PLANNING COMMISSION AGENDA

Thursday, July 19, 2012

Coon Rapids City Center

Subject: PC 12-14 North Suburban Eye Specialists Site Plan Office Building

site plan

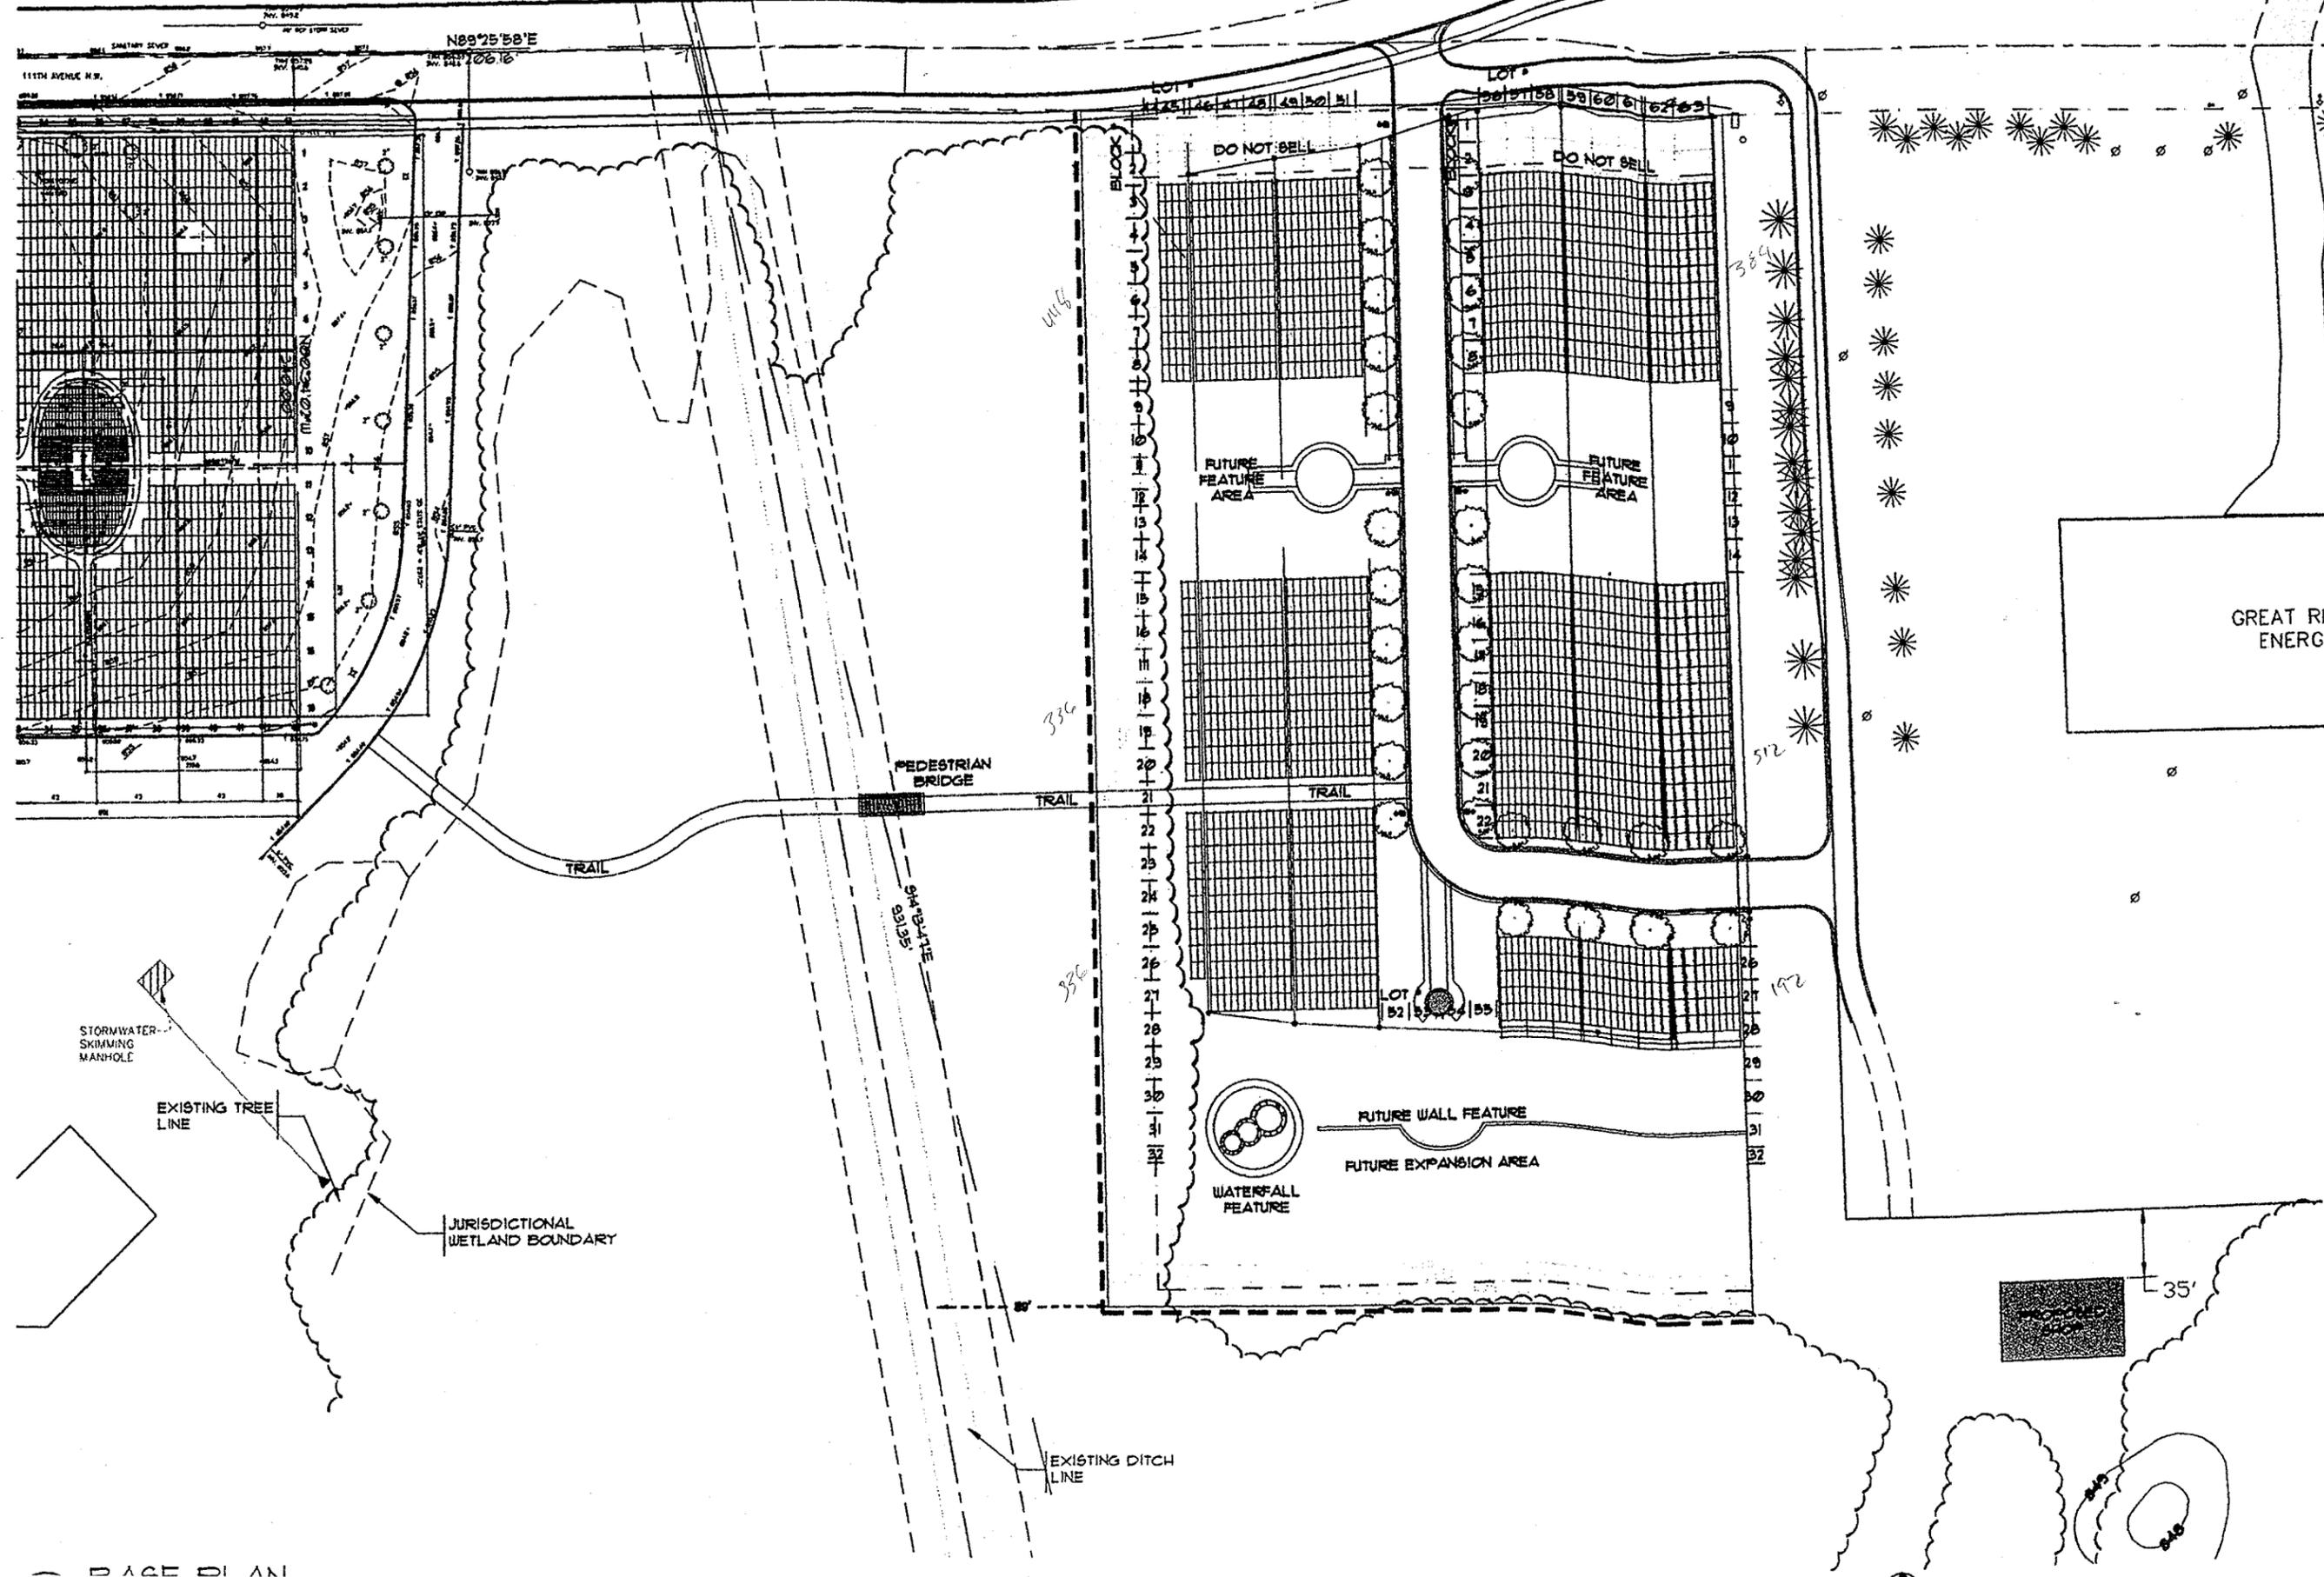
At the June 21st meeting a resident and the Commission discussed their concerns regarding grading, drainage and the dumping of debris to the rear of the cemetery. The Commission also discussed the construction of a fence along the rear of the cemetery to discourage people from going in back of the cemetery. The church will have representatives at the July 19th meeting to answer questions and respond to the concerns raised at the June 21st meeting.

Commissioner Stephenson questioned if the rear property line had a significant change in grade, and if the rear line would be fenced. Planner Harlicker explained a fence was not proposed.

Commissioner Geisler recommended a second condition for approval stating any work on the site, from this point forward, would need approval by the City. She noted the City does not currently have a grading plan for this site and for this reason, the item could be tabled to allow staff to discuss the item further.

1. The applicant submit a grading permit for any future grading that takes place on the cemetery site.

Site Plan

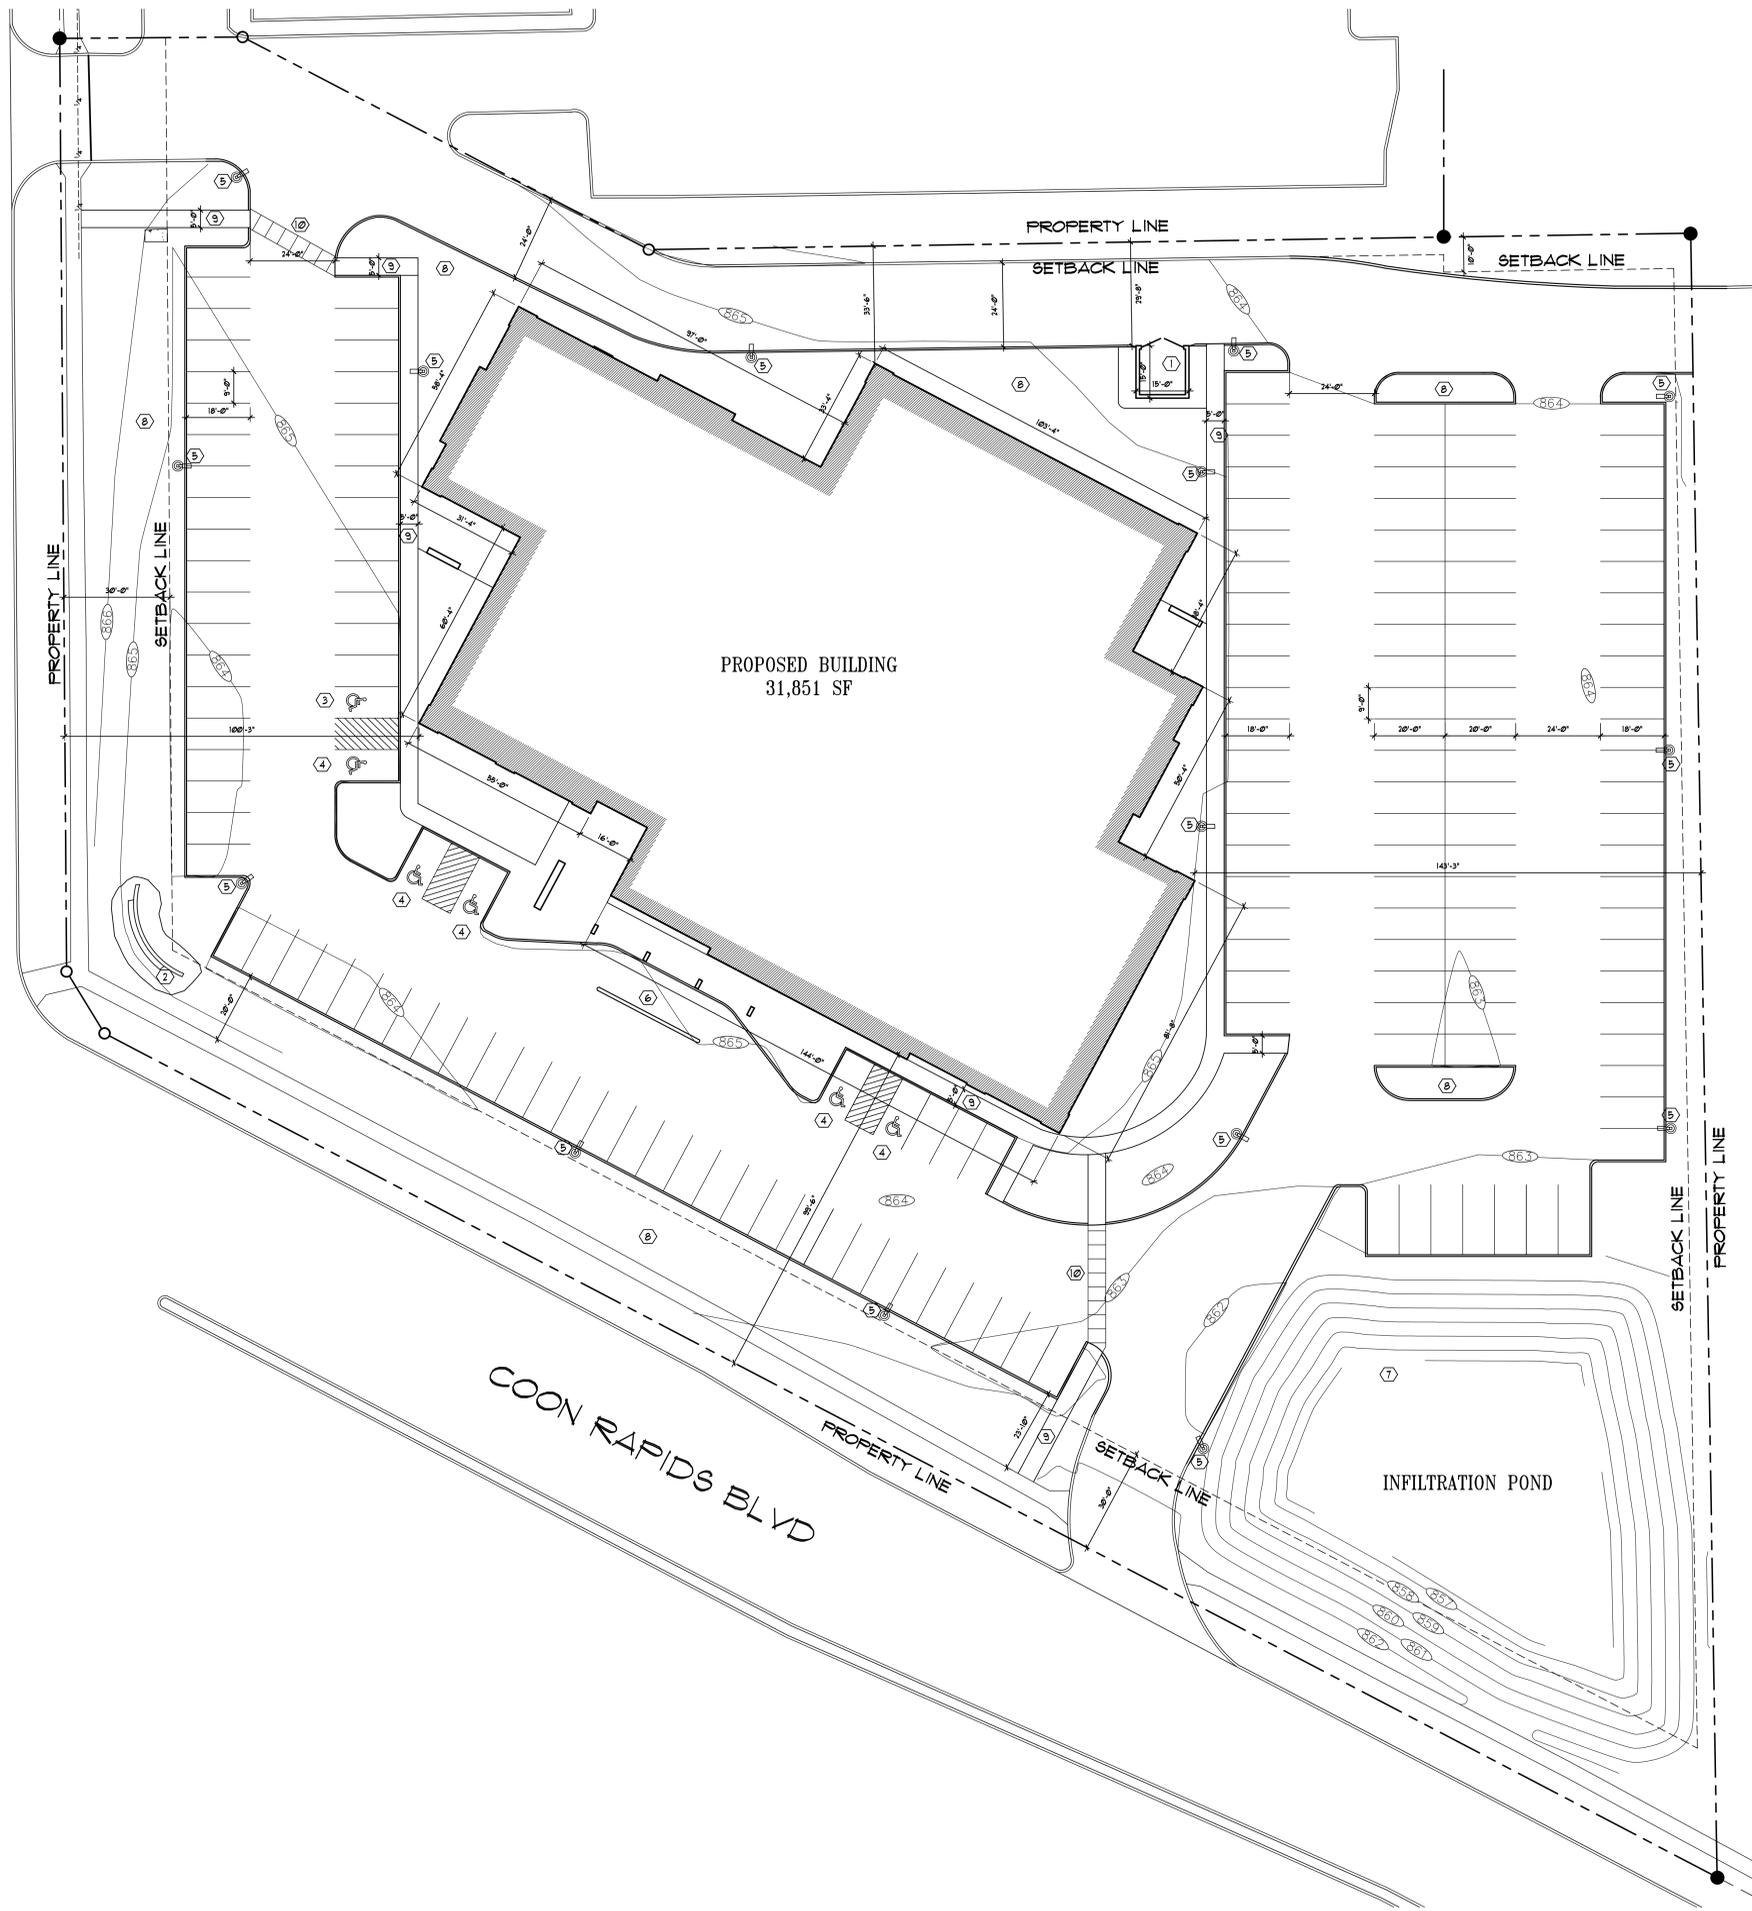
The site plan exceeds the number of required parking spaces. The code requires 149 spaces, the site plan includes 166 spaces. The spaces and drive aisles comply with the dimensional requirements.

1. Seating areas and trash receptacles be provided at the entrances.
2. The landscape plan be revised to show an additional green space overstory tree, additional 20 street frontage shrubs and an additional 128 foundation shrubs along the Coon Rapids Boulevard building frontage.
3. The property owner establish a maintenance program for the rain garden and provide the city with a copy.
